Report to the Future Melbourne (Planning) Committee

Ministerial Planning Referral: TPM-2015-15 556-558 Lonsdale Street and 560-566 Lonsdale Street, Melbourne

PLANNING REPORT

Application number: TPM-2015-15

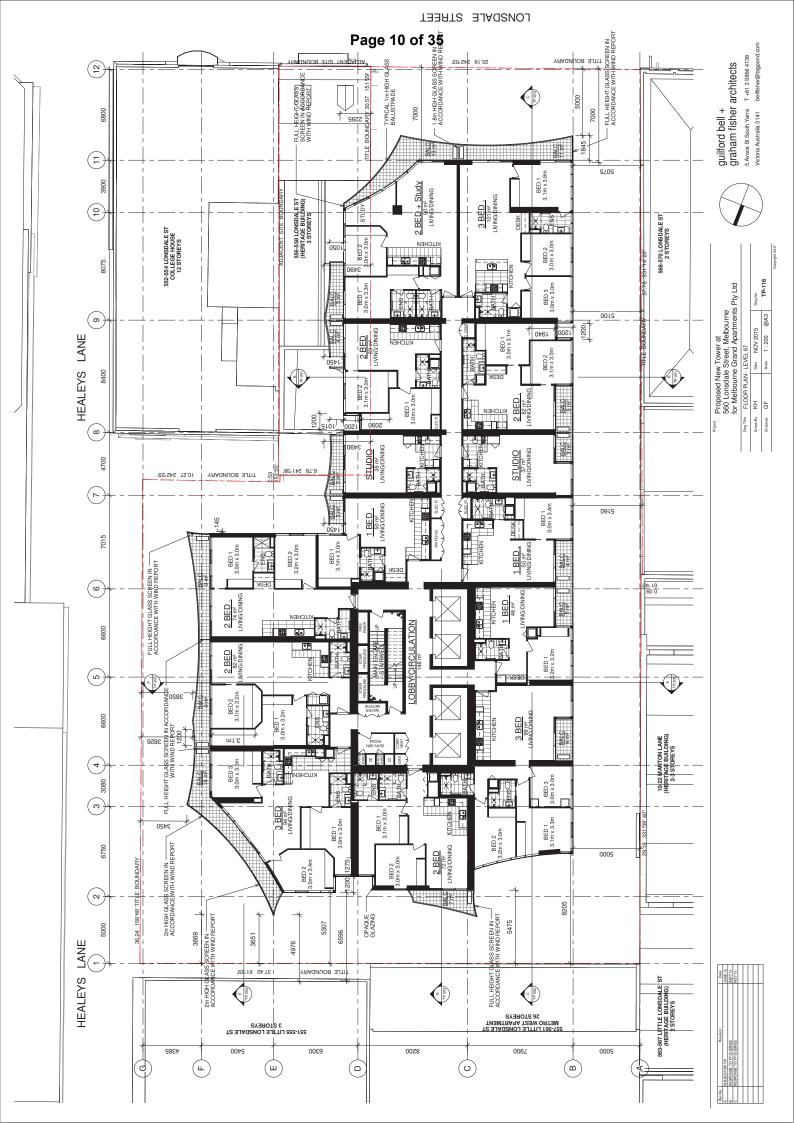
- The canopy of the building encroaching over Healeys Lane shall be designed at a minimum height of 5.0 metres from the road pavement.
- The architectural drawings TP-158 and TP-159 show alterations the footpath levels in Lonsdale Street and Healeys Lane to accommodate access to the building. We object to the proposed entrance levels to the building. The entrance levels to the building shall be redesigned to maintain the continues gradient of the footpath along the street. We also recommend to include the following condition into the planning permit:

- Prior to the commencement of the development, the detailed drawings showing the entrance levels of the building adjacent to the road infrastructure must be submitted to and approved by the City of Melbourne Engineering Services.

Ground floor plan

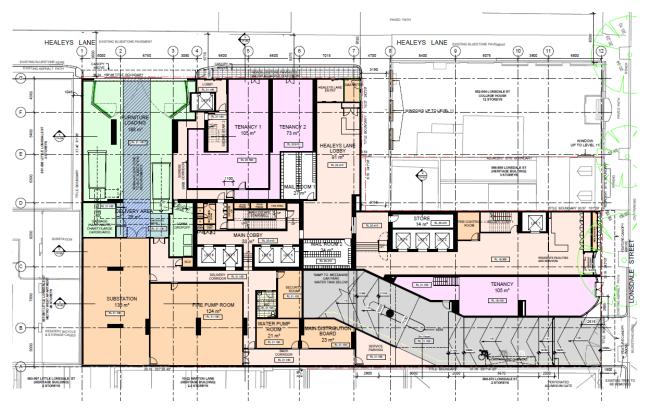
- The proposal to provide a new double width crossover to Lonsdale St is generally not supported, given that other properties along this section of the street are typically accessed via the abutting laneways rather than via Lonsdale St directly. The new crossover would result in the removal of up to 8m of Loading Zone space, which is used by neighbouring businesses.

- We object to the outward opening door projecting into Lonsdale Street. The door shall be redesigned such that it does not project beyond the street alignment when open, when closed or when being opened or closed.

The proposal to provide a new double width crossover to Lonsdale St is not supported, given that other properties along this section of the street are typically accessed via the abutting laneways rather than via Lonsdale St directly. The new crossover would result in the removal of up to 8m of Loading Zone space, which is used by neighbouring businesses, could impede pedestrian flows, and is considered to be a poor urban design outcome. Melbourne City Council Traffic Engineers have also advised that the proposed vehicle roller door is required to be setback 5 metres from the building line to prevent vehicles from queuing in the Lonsdale Street.

Perspective - King and Lonsdale Street

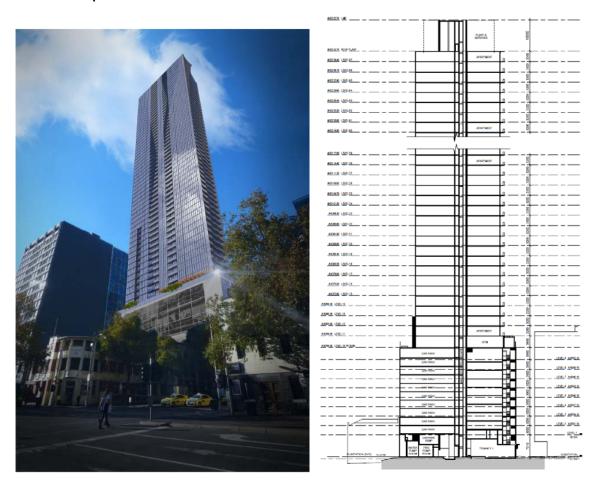
In terms of setbacks, Clause 22.01 states that towers should be setback 10 metres from street frontages. The proposal clearly does not comply with this policy with a 7 metre setback from the façade of the building and a 5 metre setback from the balconies to Lonsdale Street. The minimum tower setback in combination with the height of the building at 223.4 metres

will result in a building which will overwhelm the pedestrian and be visually intrusive and dominant from Lonsdale and King Streets and surrounds. This intrusion will adversely affect these streetscapes.
